In response to comments made at the plan commission meeting on August 8, 2016, we have made some improvements to the floor plan and site plan for the 418 Division Street project. Attached are 17 copies of those plans for staff review and distribution to the plan commission.

PROJECT TITLE  
**418 Division St.**

Madison, WI  
SHEET TITLE  
Third Floor Plan

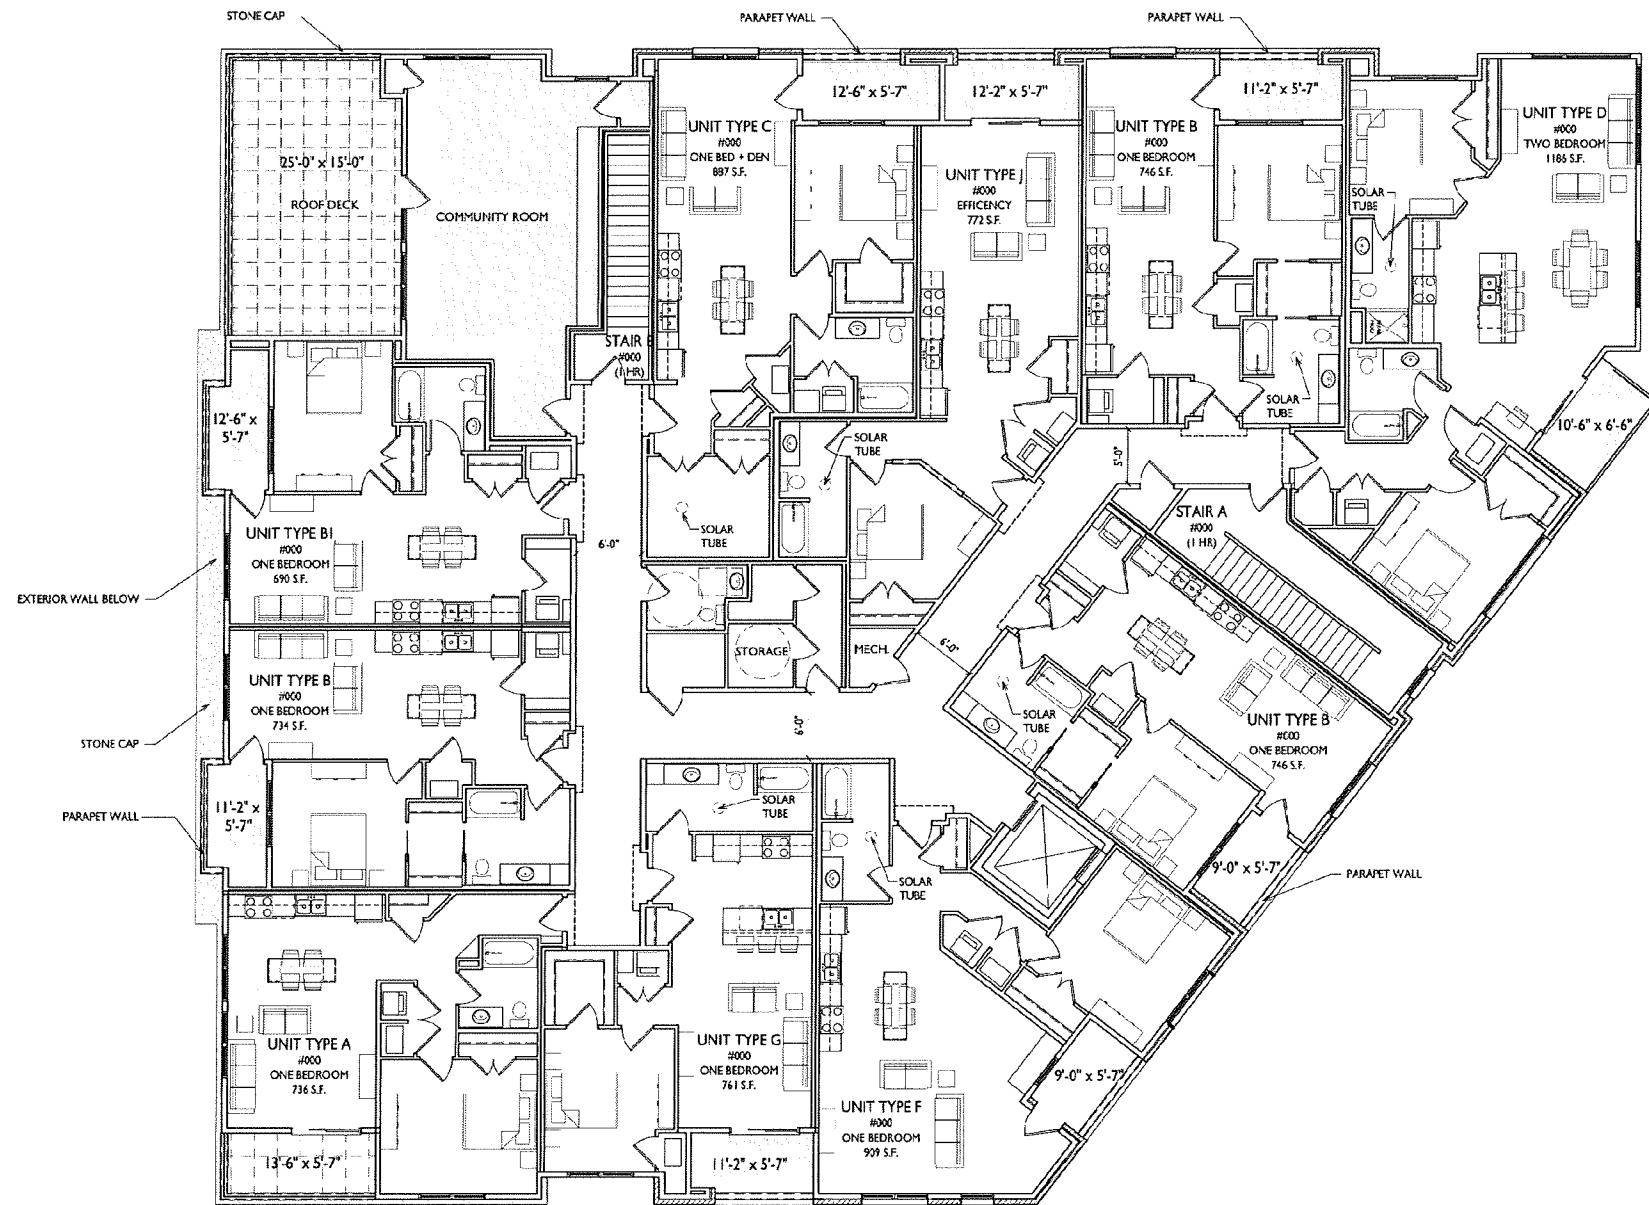
6. Increased the size of the third floor roof terrace and the community room. We redesigned the stair enclosure, which allowed us to enlarge the roof terrace and the community room space.
